UNITED STATES PATENT AND TRADEMARK OFFICE

APPLICATION NO.	FILING DATE	FIRST NAMED INVENTOR	ATTORNEY DOCKET NO.	CONFIRMATION NO.
09/531,531	03/21/2000	Yuichi Shiota	257718	7092

Office Action Summary	Application No.	Applicant(s)	
	09/ 531, 531	Shirota et al.	
	Examiner	Art Unit	
	FORD	3743

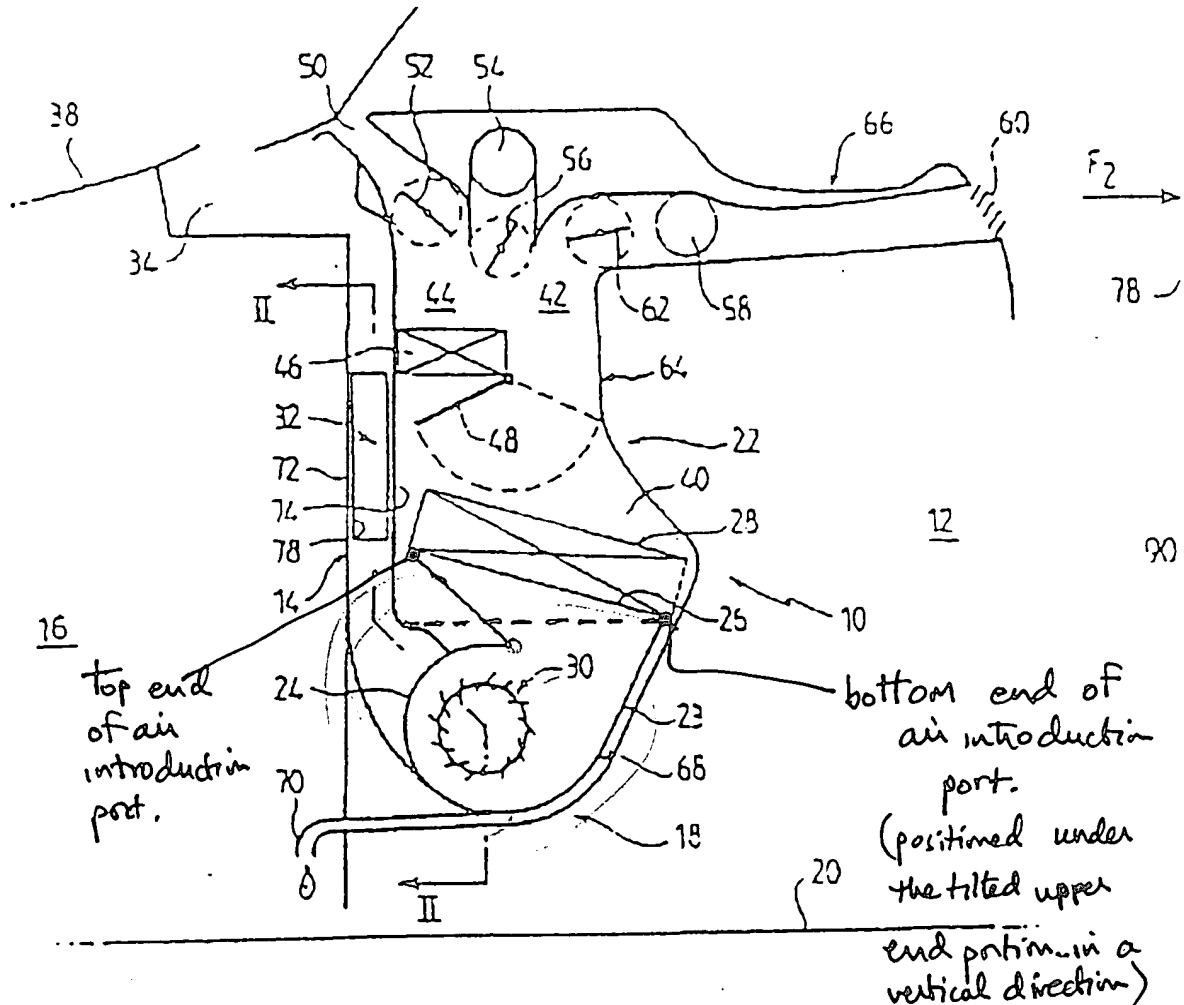
JA'365 (Fig. 50 shows the essential subject matter of claim 6 with the exception of the details of the fins on the evaporator (the evaporator is shown schematically)). Arguably, elements 13 may not be "mode members" as called forth in the claims, but the translation submitted is so abbreviated these elements are not even mentioned. In applicant's response (paragraph bridging pages 13-14 of the June 25, 2001 amendment) translations are discussed but have not been provided. Please provide full translations of JA 5-336 and JA 6-16049 response to this action. This is a repeated request. As well, the top of the fan discharge (23) appears to be slightly below the bottom of the lowest point an evaporator (6) when a horizontal line is drawn across the reference.

Contrary to applicants' statement, however, the bottom end of the air introduction port of JA'365 is clearly positioned under the tilted upper end of the cooling heat exchanger. Also, the Examiner does not know if JA '365 discloses a corrugated fin evaporator because it has not been properly translated. Moreover, Newton discloses the relationship of the air introduction port to cooling heat exchanger notwithstanding applicants' remarks to the contrary.

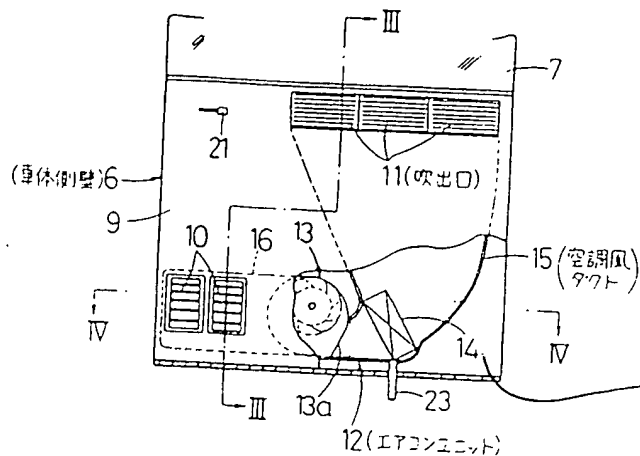
JA'049 also shows the essential subject matter of claim 6 however it too lacks a showing of fins on the evaporator 28, but does show mode control doors 52, 56 and 62. It appears to show the top end and bottom end of the air introduction port to be positioned as claimed. See the illustration below:

To have replaced elements 13 of JA'365 with the mode control doors of JA'049 to distribute air to vent, foot and defrost outlets to improve occupant comfort would have been obvious to one of ordinary skill. Alternatively, to have off-set blower 30 of JA'049 to one side of the evaporator 28 in the manner taught by Figure 5 of JA'365 to permit a

reduction in height of the unit for mounting in smaller vehicle spaces would have been obvious to one of ordinary skill.

第 2 図

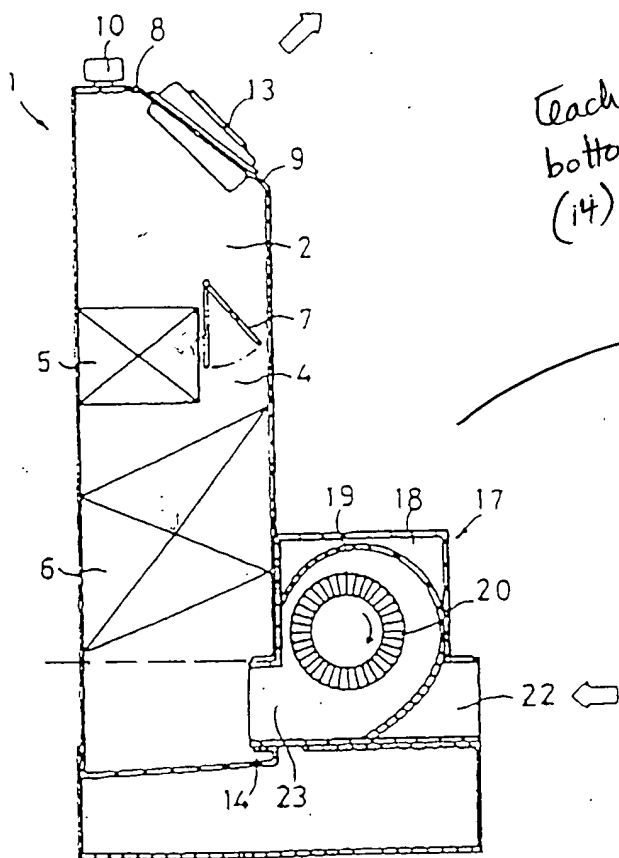
The proposed modification using JP 63-17107 as a teaching reference is illustrated below. Given this example, applicants can see that the same modification would have been obvious from any of the teachings of Stech, JP'388 (Figure 4) or Newton in the alternative. JA'107, however, is the simplest reference to understand and is used here for purpose of illustration. See next page.

teaching reference

第 5 図

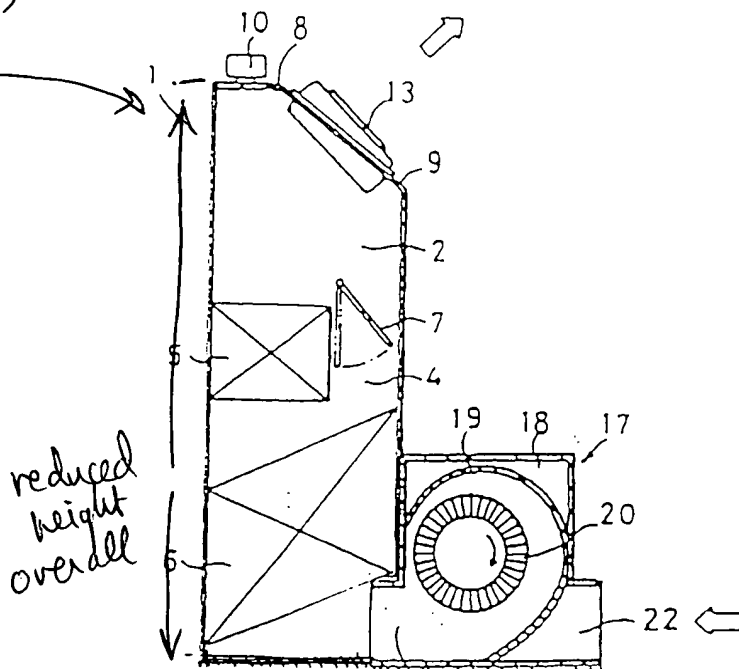
To have moved the evaporator 6 of JA'365 downward towards the bottom of the fan plenum so that the lowest point on the evaporator was below the highest point on the fan discharge aperture (23) to advantageously reduce the overall height of the unit to permit it to fit in smaller vehicles (with less vertical space) would have been obvious. This orientation of fan to evaporator is fairly taught by any one of Stech, JP'388 (Fig. 4) JP 63-17107 or Newton.

prior art

Teaching to move bottom of evaporator (14) to bottom of casing (12)

reduced height overall

modified prior art

evaporator lowered to advantageously reduce overall height of the HVAC unit
